Planning Stage Structural Report

150 Day Street

Prepared for UOL / 20th March 2025

Issue: Revision 2

LEVEL 23 PLAN - ROOFPAN

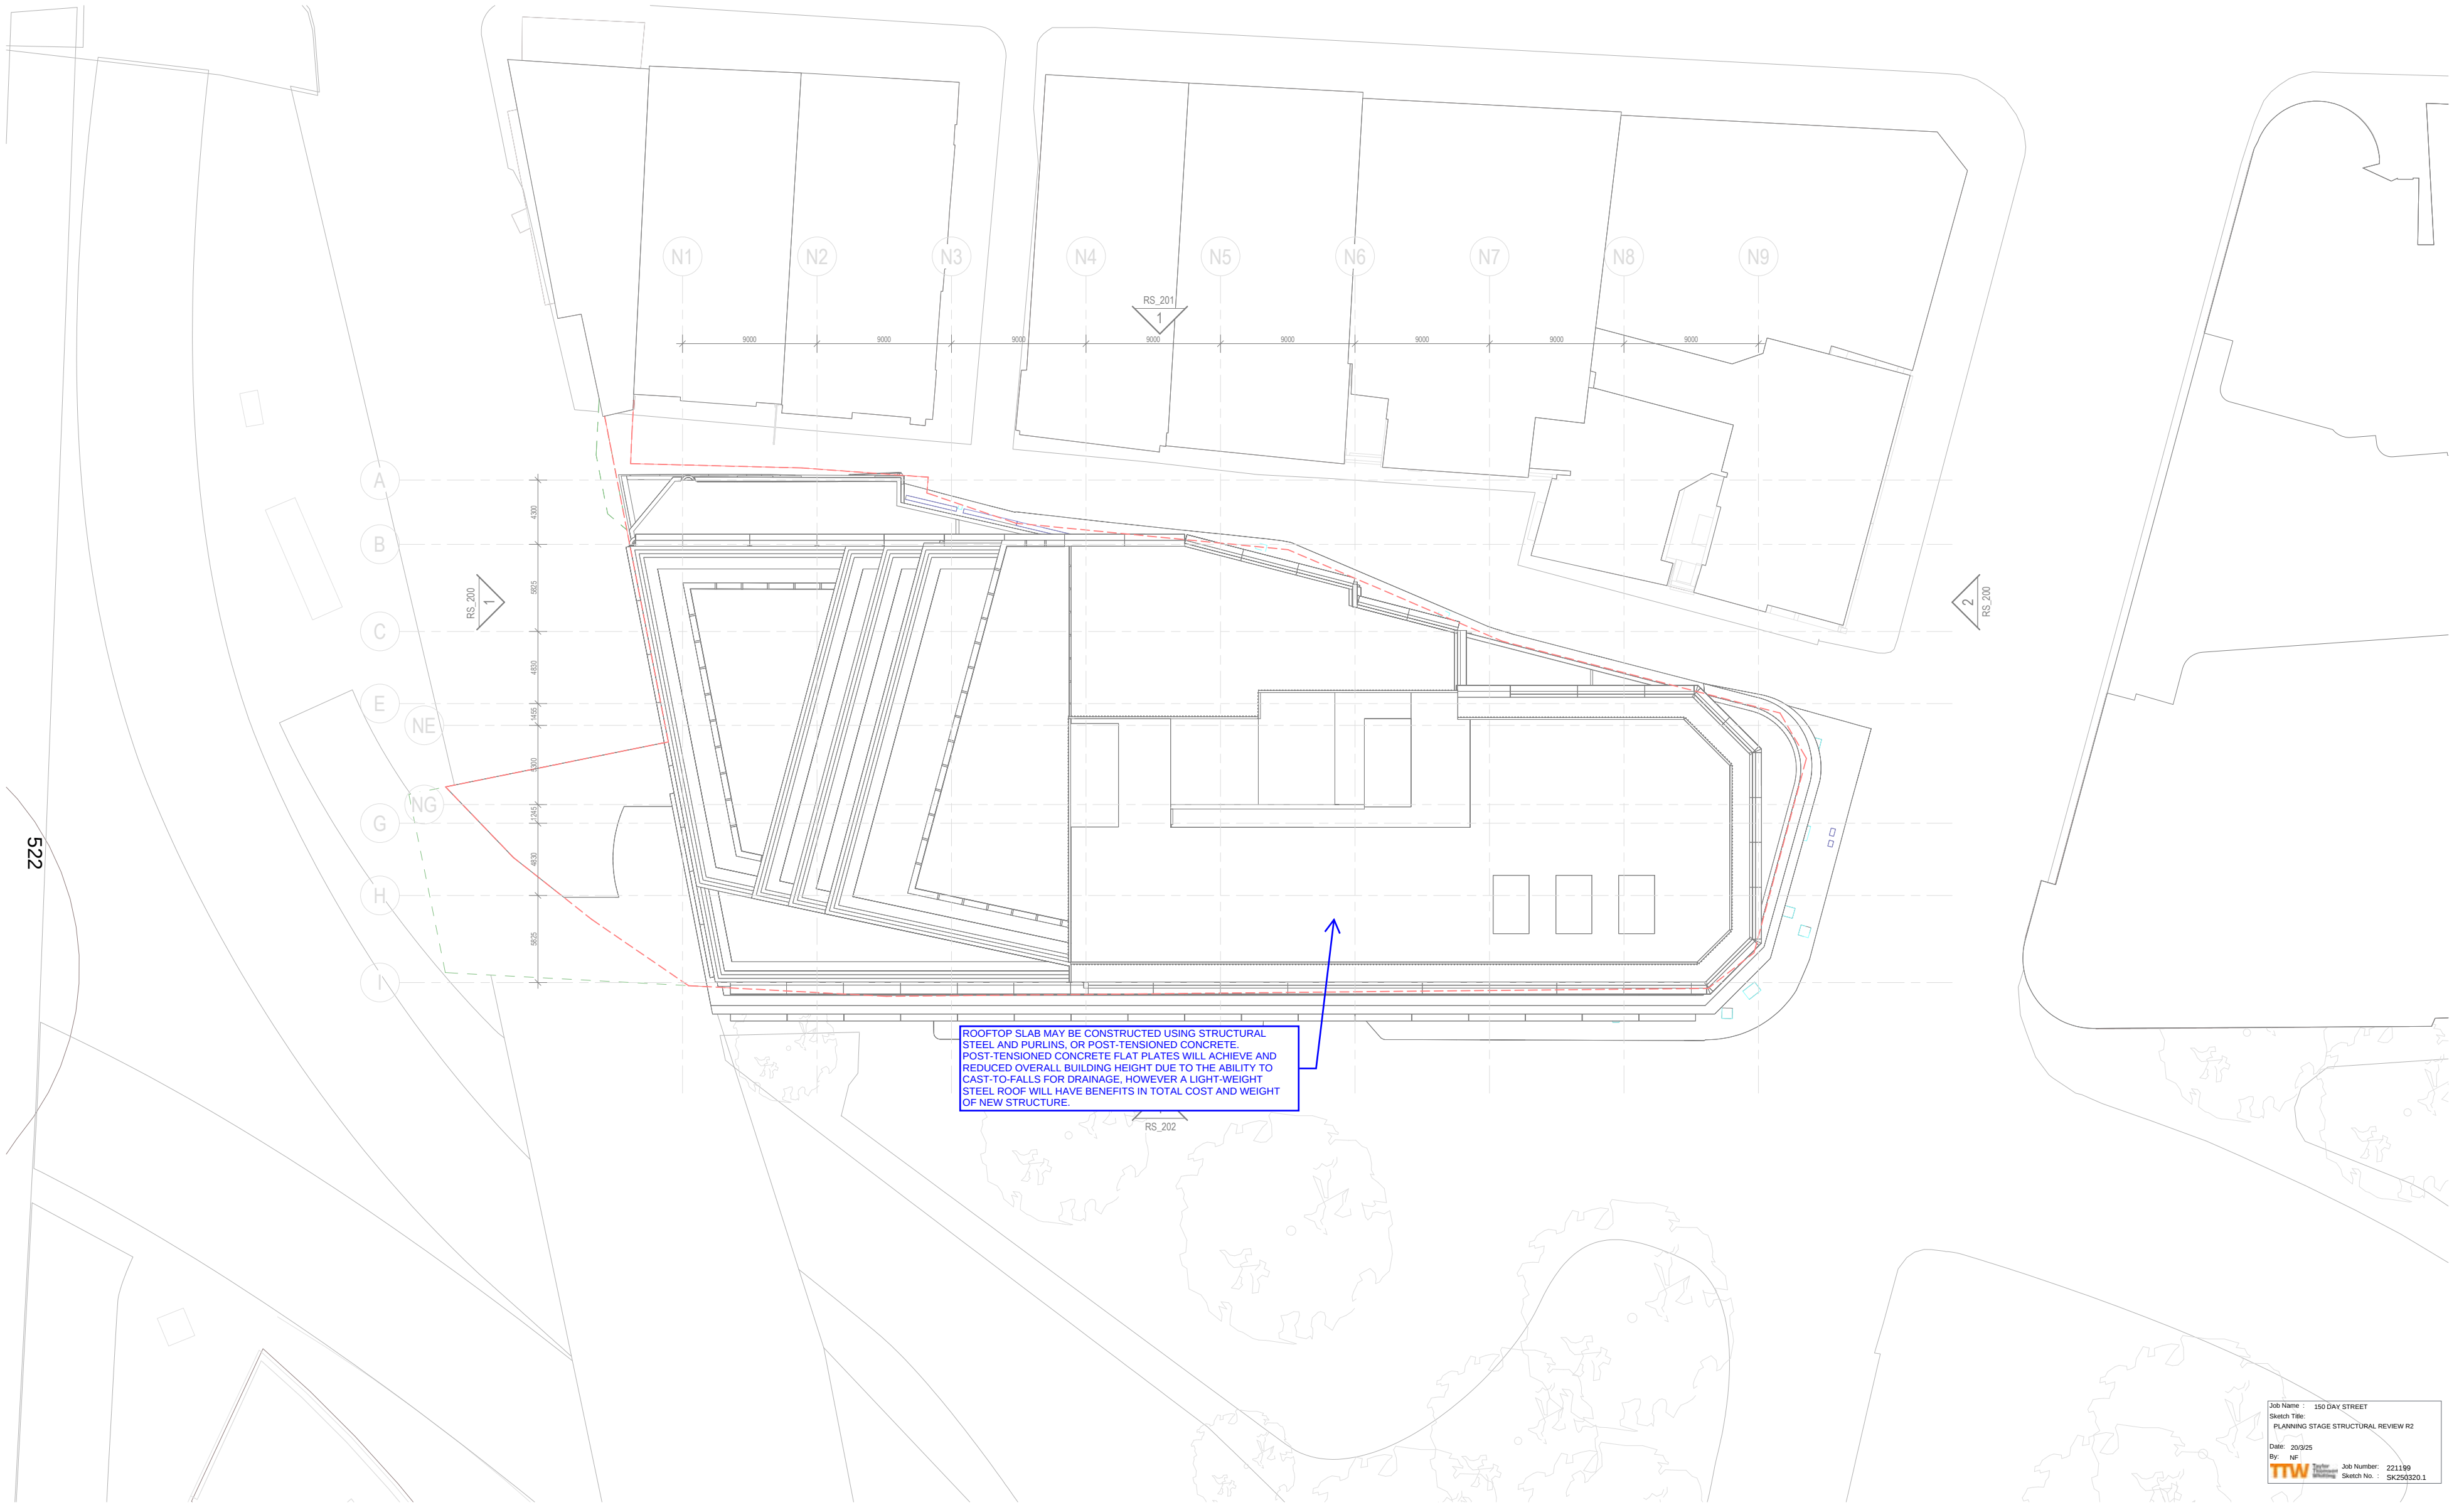
STRUCTURAL SYSTEMS CONSIDERED FOR NEW FLOORS HAVE INCLUDED:
1. POST-TENSIONED FLAT PLATE
2. CONVENTIONALLY REINFORCED FLAT-PLATE
3. COMPOSITE STEELWORK/CONCRETE
4. TIMBER AND TIMBER-HYBRID SOLUTIONS

IN GENERAL, IT IS EXPECTED THAT A POST-TENSIONED CONCRETE SOLUTION WILL LEAD TO A ROBUST SOLUTION FOR THIS SLAB. ITEMS TO BE COORDINATED AS DESIGN PROGRESSES INCLUDE:

1. FALLS AND IMPLICATIONS ON STRUCTURAL BUILD-UP.
2. DETAILED WEIGHTS OF PLANT AND WATER TOWERS TO ENSURE COLUMN STRENGTHENING IS ADEQUATE AT EXISTING STRUCTURE.
3. REQUIREMENTS FOR ACOUSTIC SCREENING AND SUPPORT OF ANY OTHER SCREENS
4. REQUIREMENTS FOR PLINTHS FOR PLANT AND ASSOCIATED WEIGHTS.
5. PLANT REPLACEMENT STRATEGIES AND ANY STRUCTURAL IMPLICATIONS.
